321 COPELAND DRIVE LAKE COPELAND HISTORIC DISTRICT

Major Certificate of Appropriateness to demolish the existing structure and rebuild in a new style.

PROPOSED ELEVATIONS OF HOUSE

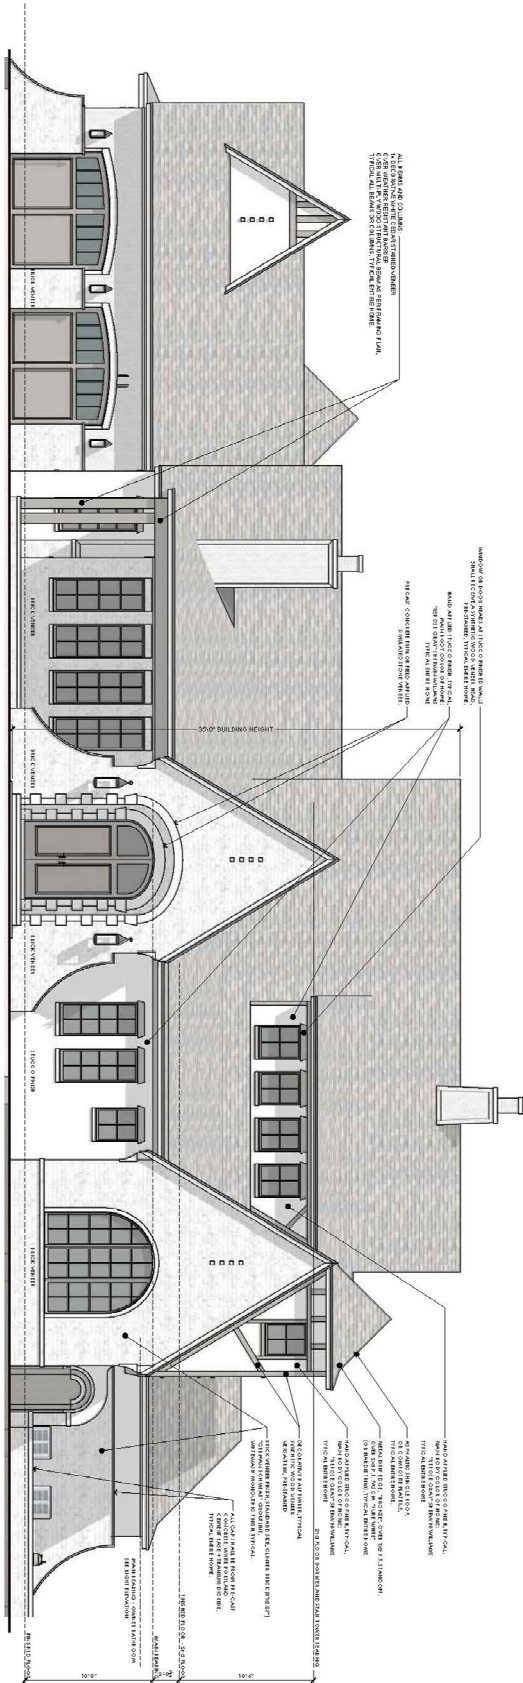
The proposed new structure draws from Tudor Revival influences which are not prevalent in the Lake Copeland Historic District. The height and scale of the structure is much larger than the existing building and the surrounding structures. No calculations have been provided regarding transparency. Windows are a mixture of fixed and casement as noted on the floor plans.

HEIGHT STUDY BY APPLICANT

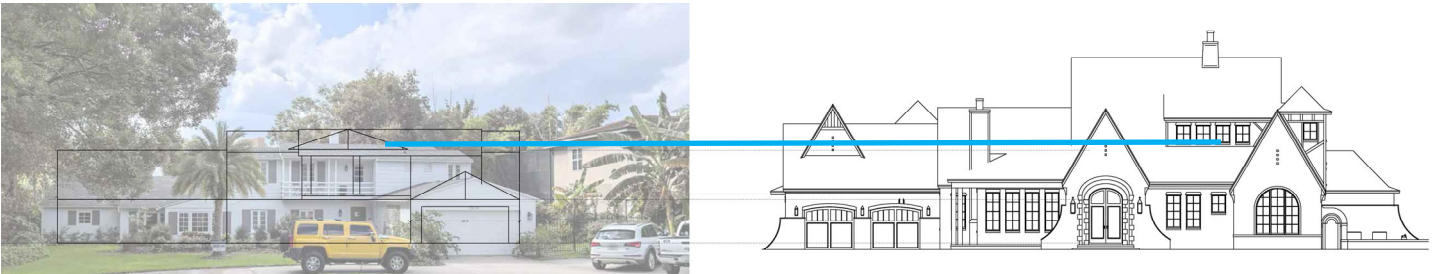
The height of the proposed structure is 29'-6", just 6" below the max. allowable. No address is given for the comparison study but it appears to be 1315 Delaney. Staff cannot confirm the scale is the same in the two images. However, it should be noted that 1315 Delaney is setback 51 ft from the lot line. It's 2 story mass is therefore reduced by its placement deeper in the lot than what is proposed at the subject property.

Although corresponding lines are not provided by the applicant, the roof is lower on 1315 Delaney.

HEIGHT STUDY BY APPLICANT

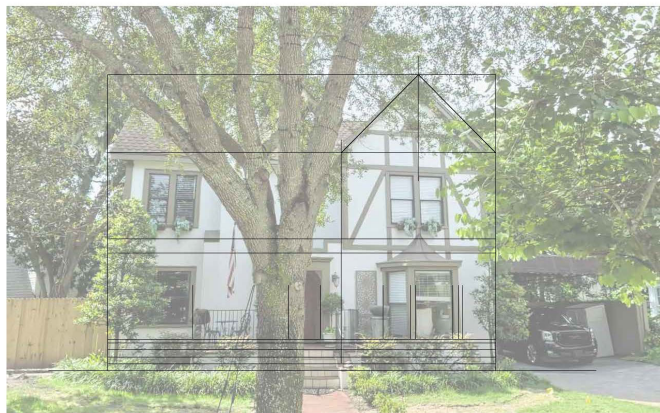
The height of the proposed structure is 29'-6", just 6" below the max. allowable. The comparison house shown here is 120 Fernwood, which is more than 2 blocks away from the subject property. And was not considered by staff for comparison but is a Tudor Revival home. Staff can not confirm the scale is the same in the two images. Additionally, no corresponding lines were provided by the applicant.

LIVING SQUARE FOOTAGE COMPARISON

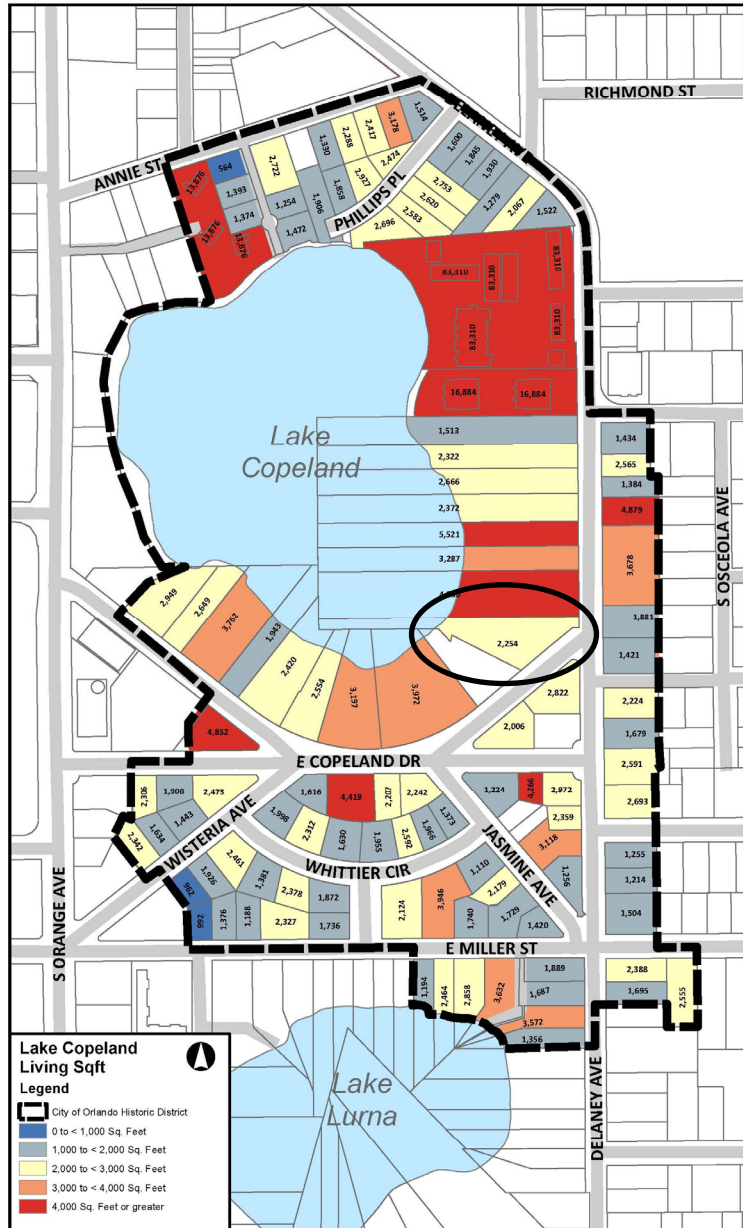
- Per the Property Appraiser, the house currently has 2250 sqft. of living space.
- The new SFR will have 4,622 sq ft, more than double the current house.
- The color indicator would change to RED, which is larger than the size of the surrounding contributing properties except one.
- FAR would be .18.
- The average living sq ft of abutting properties is 1,421 sq ft to 4,250 sq ft.
- The site will have more square footage than all neighboring properties, except one.

GROSS SQUARE FOOTAGE COMPARISON

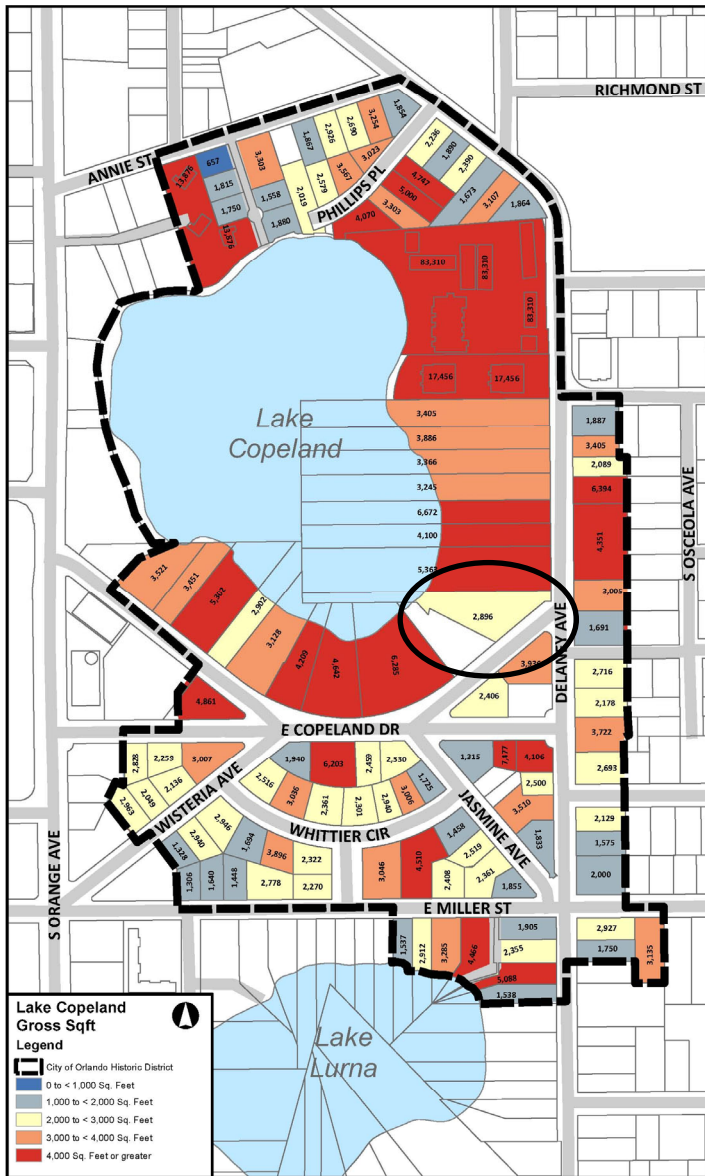
- According to the Property Appraiser, the site currently has 2892 sqft of gross square footage, which compares to the YELLOW colored properties.
- Staff was unable to determine the gross sq ft from the information provided. The building pad is described as 6,585 sq ft., which includes the living areas, rear porch, front porch, and second floor rear balcony.
- The immediate surrounding contributing structures within the Lake Copeland Historic District are between 1,691 sq. ft. to 6,285 of gross square footage.
- This property would have a gross square footage in excess of the majority of contributing structures in the surrounding area.
